Errata

MX1ADSERRATA
Rev. 1, 04/2003

Errata of M9328MX1ADS/M9328MXLADS

1 IO pad voltage for Bluetooth Module

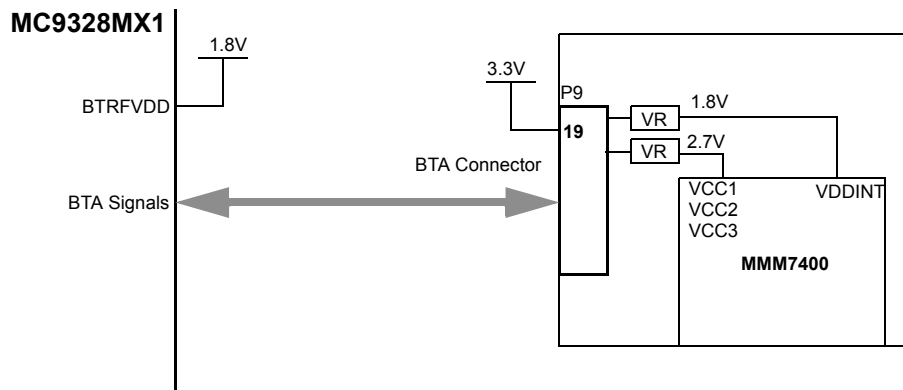
The IO pad supply voltage of MX1's BTA (BTRFVDD) should not be connected to 3.3V. According to the specification of MMM7400, the IO pad voltage is needed to be at 1.8V logic level.

The 3.3V supply to BTRFVDD will only degrade the sensitivity of the Bluetooth RF module.

The BTRFVDD is needed to be connected to 1.8V supply instead of 3.3V supply. The following is the change.
